To: Members of the Facility & Plan Review Subcommittee
Los Angeles County Solid Waste Management Committee / Integrated
Waste Management Task Force

From: Kate Downey, Sunshine Canyon Landfill

Date: March 28, 2023

Subject: **Proposed Joint Technical Document Amendment Application
Submitted to the Local Enforcement Agency**

Exhibit A-2
DEPT. OF REGIONAL PLANNING
APPROVED
1/9/07

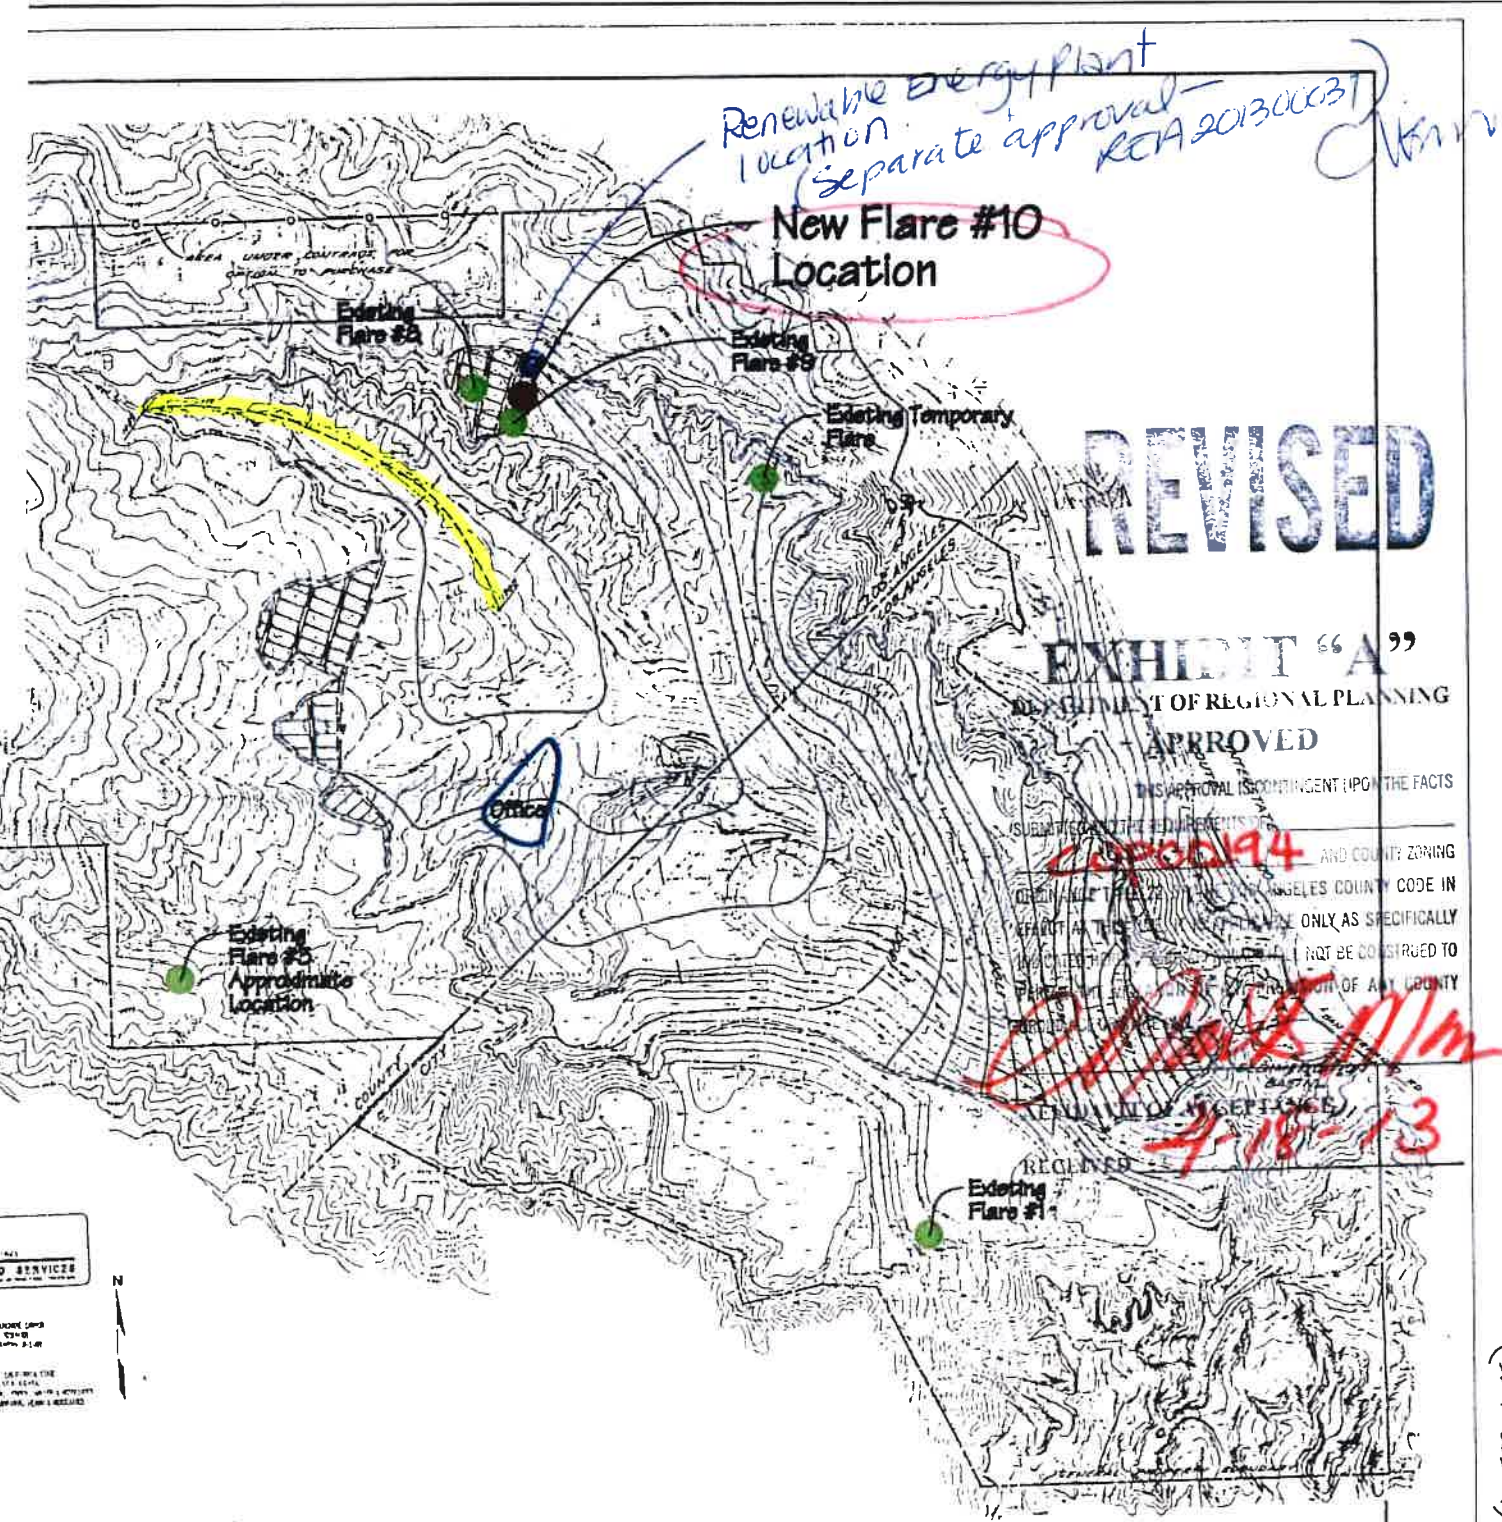
The Staff Report indicates that within Sunshine Canyon Landfill's recent JTD Amendment Application Package to the SCL-LEA, there were three items "inconsistent with the CUP and Revised Exhibit A-2: final fill contours, maximum elevations, and termination date of the landfill". The application package was rescinded and will be resubmitted with some additional minor modifications. We also wish to provide the following clarifying remarks:

Closer inspection of the contouring on the revised Exhibit A-2 shows a single, hashed contour line centralized inside the 1,875-contour line, which has been highlighted in yellow for reference in the attached copy of the revised Exhibit A-2, and represents the 1,904-contour line.

Condition 17.B.5 of the Solid Waste Facility Permit states "The permitted maximum elevation of 1,904 ft. (MSL) on portions within the County of Los Angeles boundary shall include the final cap and cover within the maximum elevation of MSW not exceeding 1,900 ft. (MSL)...".

The proposed grading in the JTD amendment shows an ultimate buildout of the Combined City/County landfill which does not exceed 1,904 on the County portion of the landfill, which is consistent with the Exhibit A-2 of the CUP and the Solid Waste Facility Permit.

EXHIBIT NO. E-4B

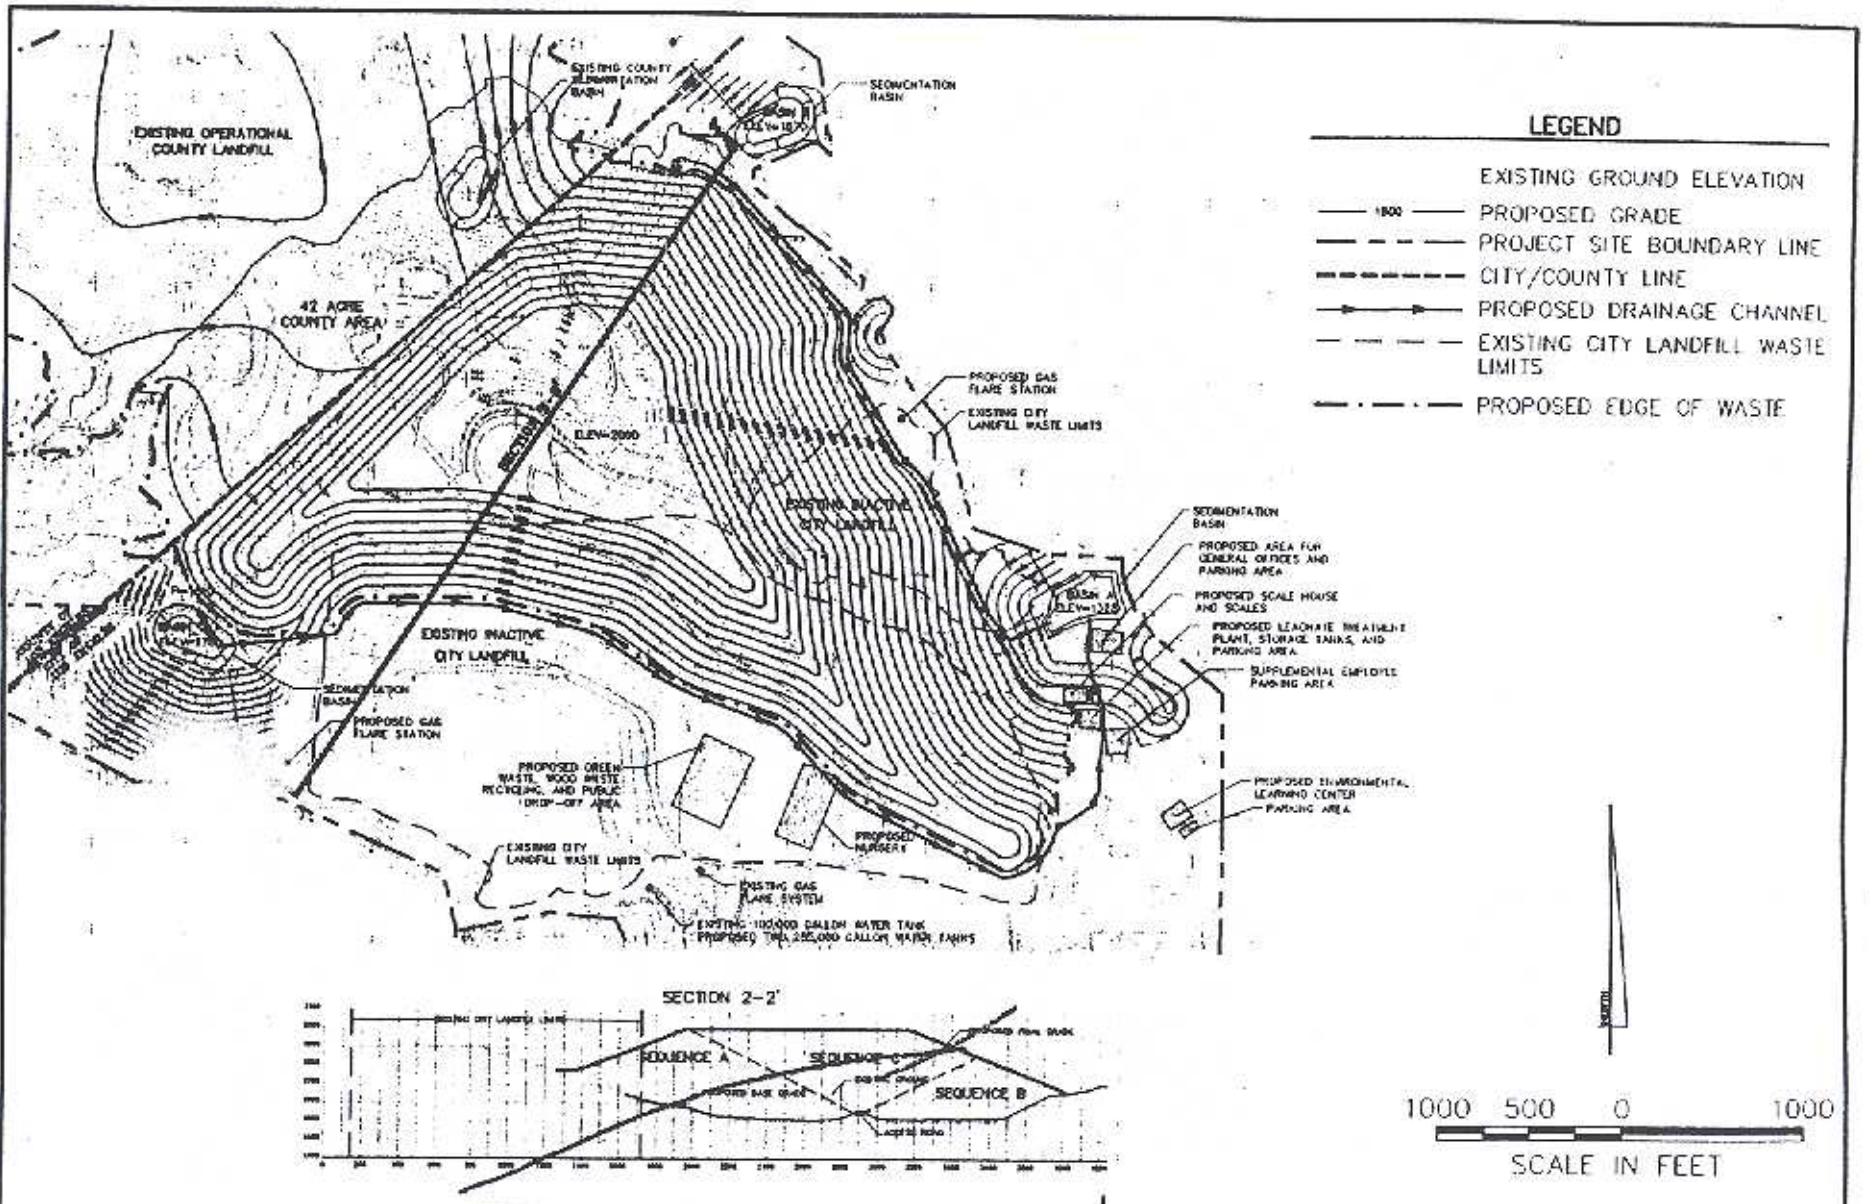
Condition B.2.d.2 of the City's Q Conditions says the combined City/County landfill at build out "would result in a final fill elevation (at its top deck) of 2,000 M.S.L. as shown in Exhibit E-4B and E-4C."

Exhibit E-4B shows a top deck with the number "2000" in the center of the top deck, which is a flat area that slopes downwards towards the City/County boundary line. (See attached Exhibit E-4B.)

The proposed grading in the JTD amendment shows an ultimate buildout of the Combined City/County landfill which does not exceed 2,000 MSL on the City portion of the landfill. The Q Conditions further state that the restrictions on the landfill only apply to the "final fill elevation" and this 2,000 MSL elevation refers only to the maximum vertical limit of waste disposal.

This is also consistent with the landfill Solid Waste Facilities Permit, which allows a maximum elevation of 2,004 ft. (MSL) on portions of the Combined City/County landfill within the City of Los Angeles boundary.
